# Access Compliance Report

## Public Rights-of-Way

### (Curb Ramps)

| Intersection ID: 10025931 | Main Street: ELLINGTON_PARK_DR | Cross Street: N/A       | Location: NW           |

| ADA ID: 5BFE7C1CED3D      | Ramp Type: BlendTrans2         | Initial Pass/Fail: Fail | Overall Compliance: No |

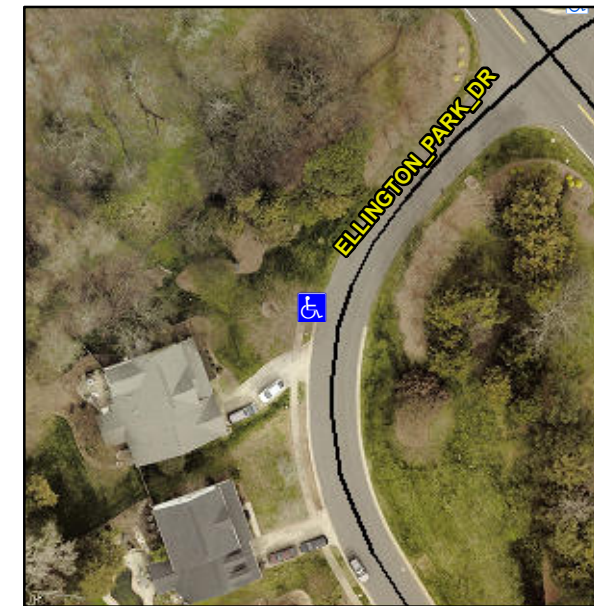
**Not Found, R302.7**

| Compliance | Description           | Data  | Compliance | Description                 | Data |
|------------|-----------------------|-------|------------|-----------------------------|------|
|            |                       |       | No         | Surface Condition? (G/P)    | Poor |
|            |                       |       | No         | Curb Slope (%)              | 17.4 |

**Remove & Replace Curb Ramp With Two New Directional Ramps or Equivalent.**
